From: Terry Morris <tpmorris.landuse.law@comcast.net>
Sent: Wednesday, October 28, 2020 3:26 PM
To: Katie Whewell; John Daghlian; 'Andrea Kelley'
Cc: Richard Lipof; 'Braden Houston'; 'ron jarek'; 'VTP Associates Inc.'; Nadia Khan
Subject: RE: 68 Chestnut Street: Parking Space Turning Radii
Attachments: 68.Chestnut.St.Prop.Cond.Plan.10.9.20.(BLOWUP).pdf; 68.Chestnut.St.Proposed Conditions Plan.10.9.20.pdf

**TOPOGRAPHIC SITE PLAN
NEWTON, MASSACHUSETTS**
SHOWING PROPOSED CONDITIONS
AT #68 CHESTNUT STREET
SCALE: 1in.=10ft. DATE: AUGUST 21, 2020
REVISED: OCTOBER 9, 2020
PROJECT: 220112

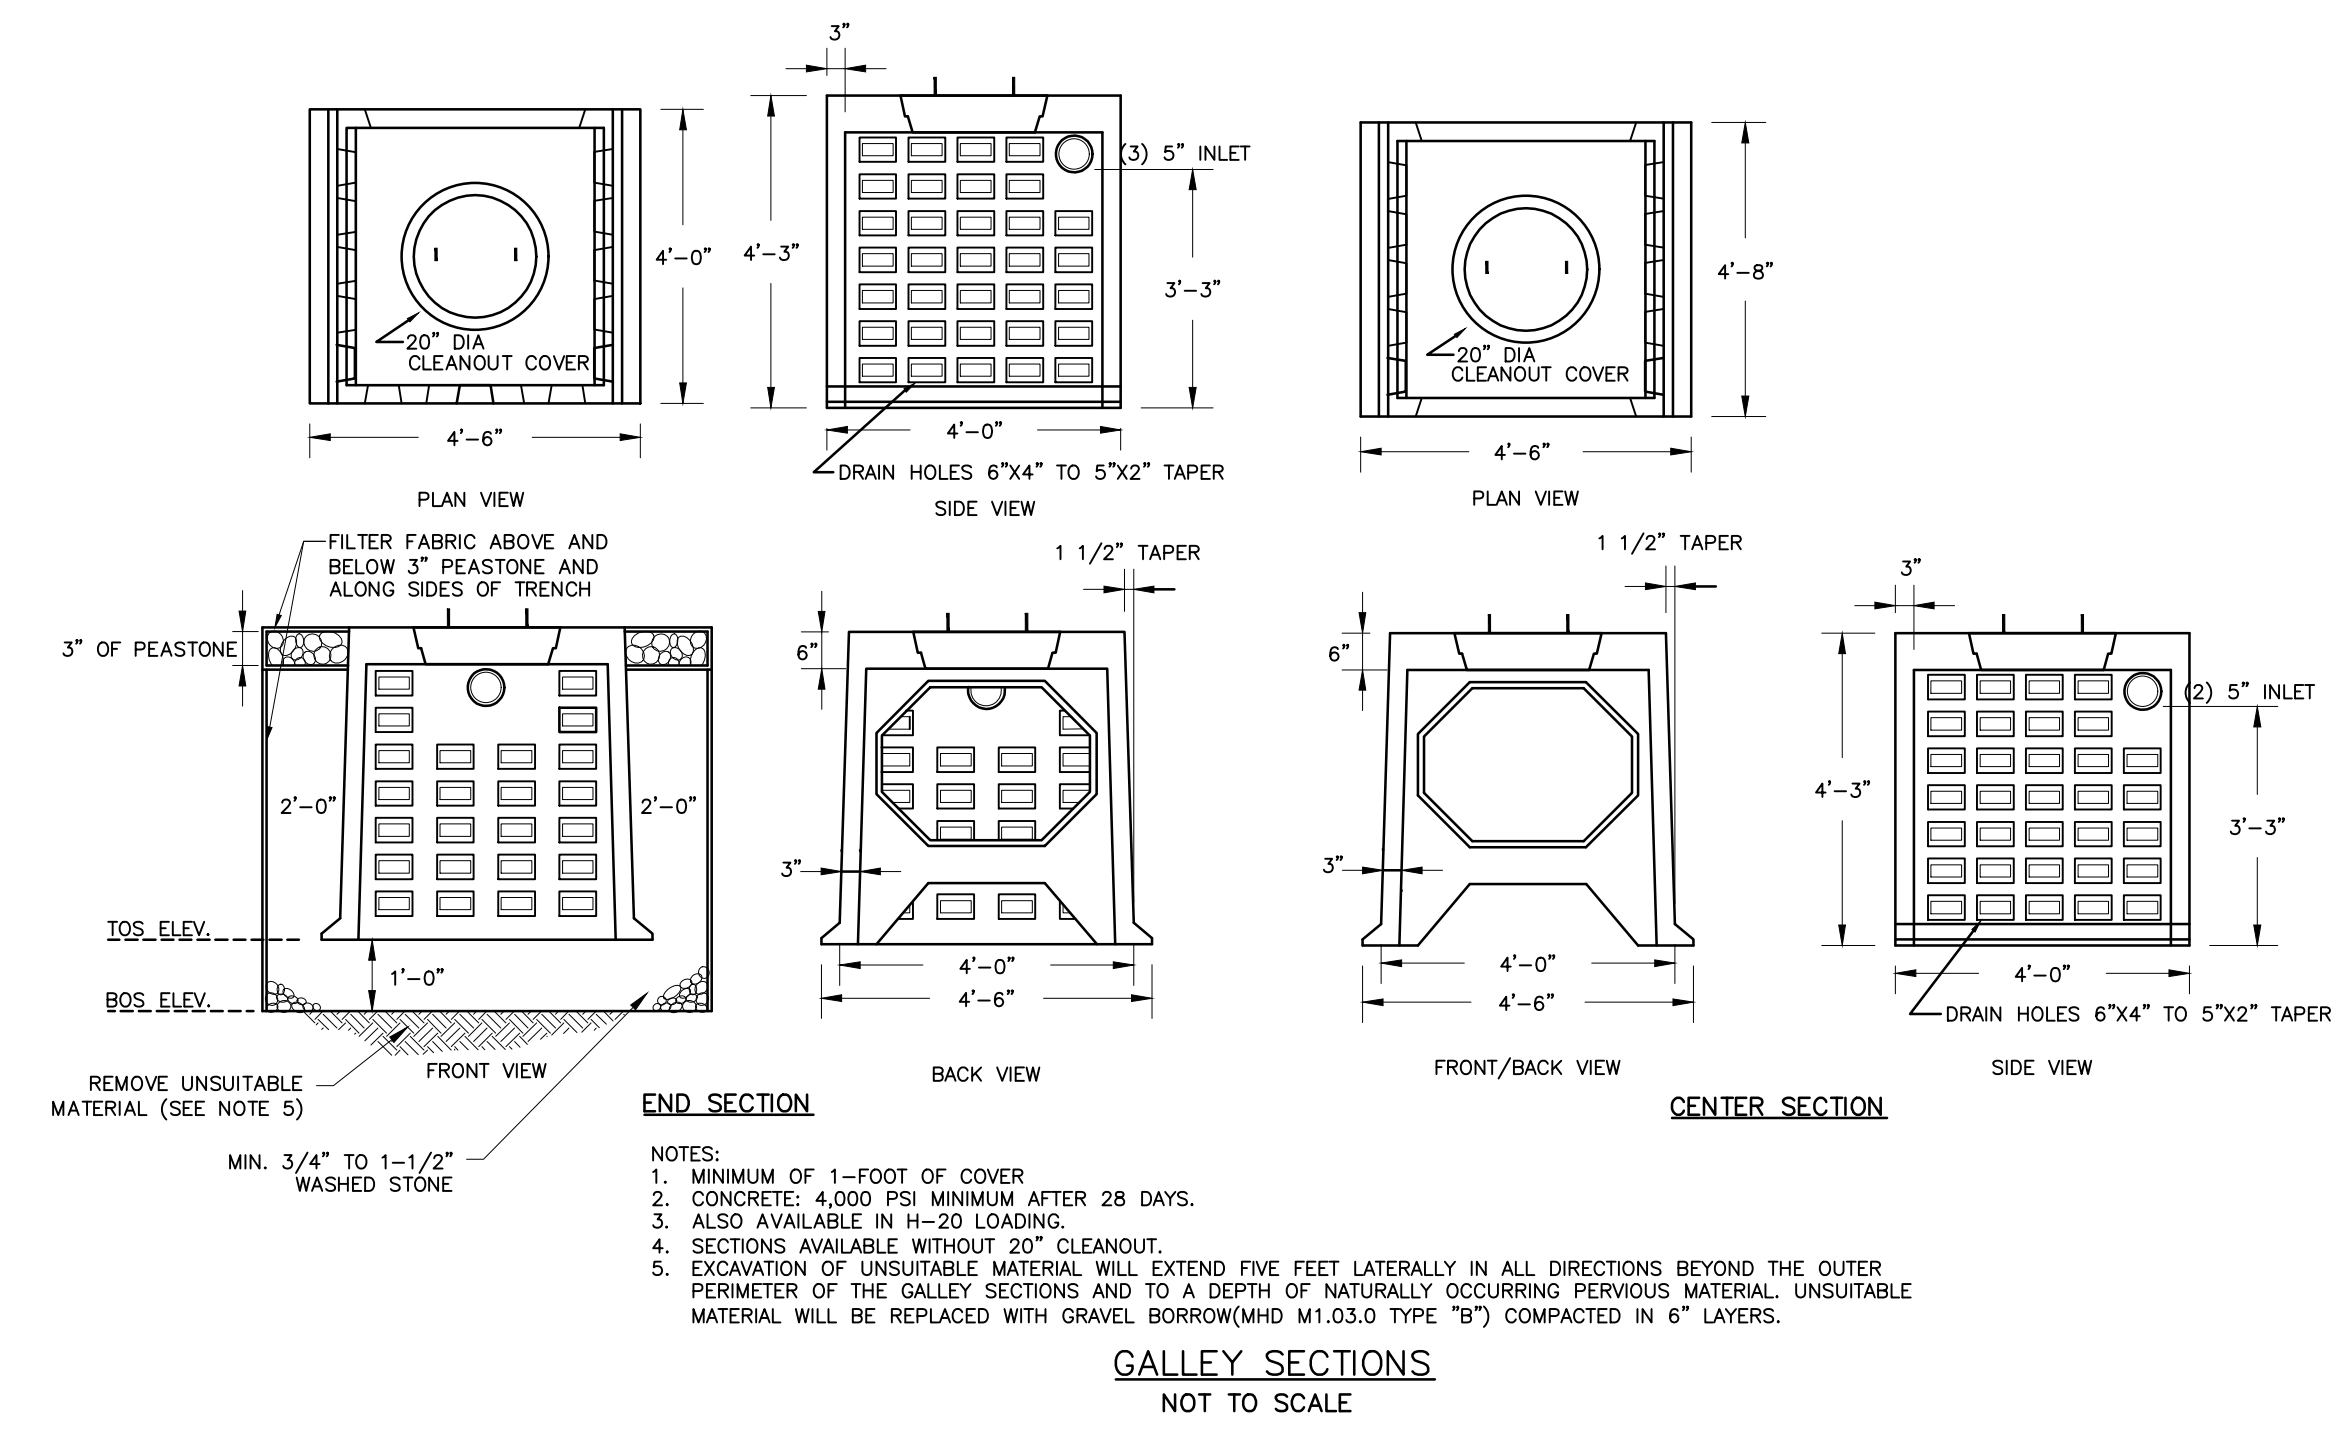
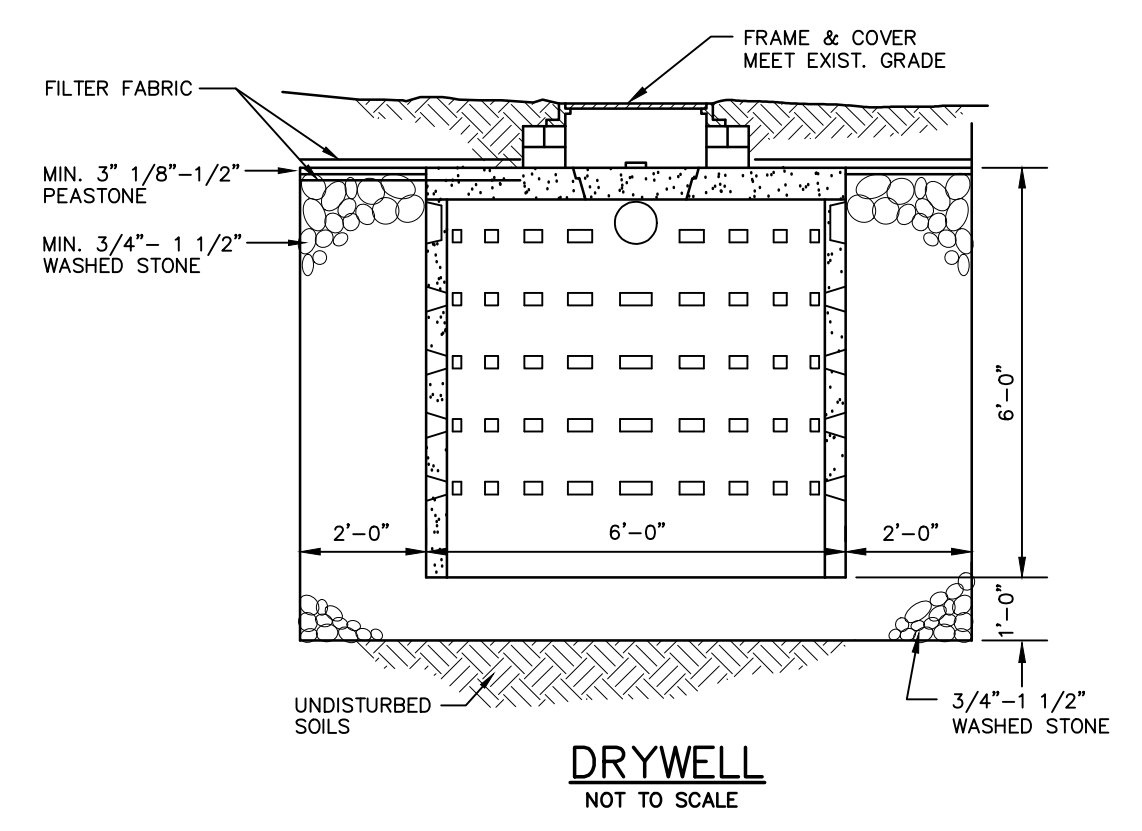
I'm not sure if John has reviewed but I am having trouble understanding why all of the spaces turning templates weren't included and understanding which car is being used to illustrate the turning between the compact and SUV.

Katie, that driveway width for entering and exiting the parking spaces under the structure looks to be about 18' wide, not even the 24' we'd normally expect for an aisle. The vehicles they show on this plan are about 14' long vs. the average of 15-16'

In the interest of having everyone being able to understand what is being presented, kindly let me explain. I will first try to respond to Councilor Kelley's observation about the length of the aisle width (i.e., backup space). It is apparent that the turning radius plan, which is not dimensioned, must be read in conjunction with the most recent Proposed Conditions Plan dated 10/6/20, a copy of which is attached. For greater visibility and ease of review I have also attached a blowup of that Plan highlighting the parking spaces.

The parking spaces are shown on the plan are outlined with dashes and highlighted in yellow. I call your attention to the dimension of 20.6 feet which measures the distance from the property line to the nearest face of the building at the 1st floor/second level. Remember the 1st floor/second level has a 4.0' cantilever over the garage/parking level. Allowing for 6" retaining wall, the maneuvering (backup) aisle width from the face of the retaining wall to the limit of the parking space(s) is twenty-four feet (24.0')(20'+4'). Twenty-four feet (24.0') is the standard required dimension for a maneuvering aisle "*providing access to stalls with two way traffic*" (NZO Section 5.1.8.C.2). Twenty-four feet allows for a vehicle to back straight out without the necessity of a turning movement. For that reason there is no need to show turning radii for the parking spaces 3-8, which should answer Katie's question.
